SSI-9717 Snowy 2.0 Transmission Connection – Independent Environmental Audit Construction Audit 3 – Proponent Responses to Audit Findings

Snowy 2.0 Transmission Connection Project - Independent Environmental Audit Construction Audit 3

Snowy 2.0 Transmission Connection Project Independent Environmental Audit – Construction Audit 3
Proponent Responses – Non-Compliances

Figure 1: Area where clearing works were assumed to have been undertaken using an excavator mulcher, shown in red (Source Leneco, 2025)

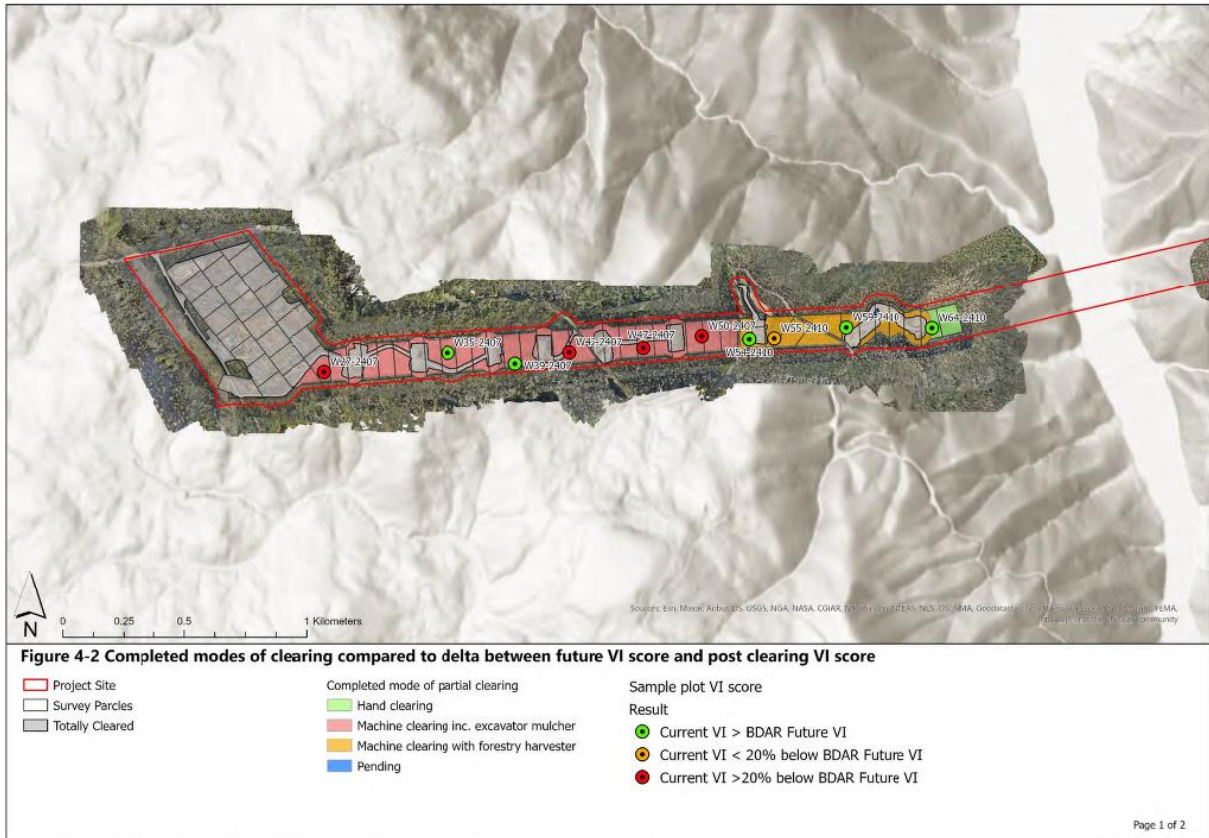
The IEA found that clearing works within the Easement Clearing Zone (ECZ) on the Project West site "west of Track 1 along the alignment to the Maragle site" (Umwelt, 2025, p. 29), shown in red in Figure 1, did not comply with the Biodiversity Management Plan [BMP] (Transgrid, 2024).

Specifically, the IEA found that during vegetation clearing undertaken between February and May 2024 the use of an excavator mulcher and a forestry mulcher, rather than a forest harvester, for removal of trees over 200 mm diameter at breast height (DBH) has resulted in the extensive application of wood mulch, to depths of 200 mm and that the excessive application of mulch is likely to have resulted in significant groundcover disturbance and compromised the retention of managed shrub and groundcover vegetation.

The IEA attributes observed impacts to the “use of the excavator mulcher and forestry mulcher for the removal of trees over 200mm DBH on the Project West site” and this does “not comply with the BMP’s requirement to use a forest harvester for trees over 200 mm DBH” (Umwelt, 2025, p. 29).

In considering whether clearing was consistent with the BDAR and the BMP, the machinery used must be considered. The IEA (Umwelt, 2025) assumes use of an excavator mulcher in these areas. It appears this assumption is based on statements in the Leneco (2025) report (see above). However, review of photographs from Umwelt (2025) indicate that a forest harvester, not an excavator mulcher, is likely to have been used, at least in some areas, with large tree trunks evident (Plate 1), consistent with use of a tree harvester and not an excavator mulcher. Rather than leaving large trunks intact on the ground an excavator mulcher would have chipped all vegetation and resulted in only mulch (i.e. no large trunks).

It is my view that clearing is largely consistent with the BDAR and BMP. Based on advice from Transgrid, clearing was undertaken using the correct machinery, with use of an excavator mulcher
